UNITED STATES  
DEPARTMENT OF THE INTERIOR  
BUREAU OF LAND MANAGEMENTFORM APPROVED  
OMB No. 1004-0137  
Expires: July 31, 2010**SUNDRY NOTICES AND REPORTS ON WELLS**  
*Do not use this form for proposals to drill or to re-enter an abandoned well. Use Form 3160-3 (APD) for such proposals.***SUBMIT IN TRIPLICATE - Other instructions on page 2**

**Dodd Federal Unit #30**

**30-015-25230**

**Permanent Abandonment of Federal Wells**  
**Conditions of Approval (LPC Habitat)**

## Dodd Federal Unit #30

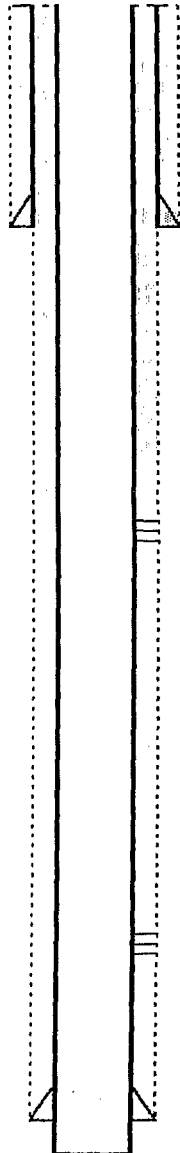
2. Spot 25 sx @ 1320-1220'. (B/Salt). WOC & Tag. 1100-990

3. Spot 25 sx @ 390-290'. WOC & Tag. 460

3. Spot 25 sx @ ~~390-290'~~ WOC & Tag.

2. Spot 25 sx @ ~~1320-1220'~~ (B/Salt). WOC & Tag.

1. Set 5 1/2 CIBP @ ~~2800'~~. Circulate hole w/ mud laden fluid. Pressure test  
csg. Spot 25 sx @ ~~2800-2650'~~.
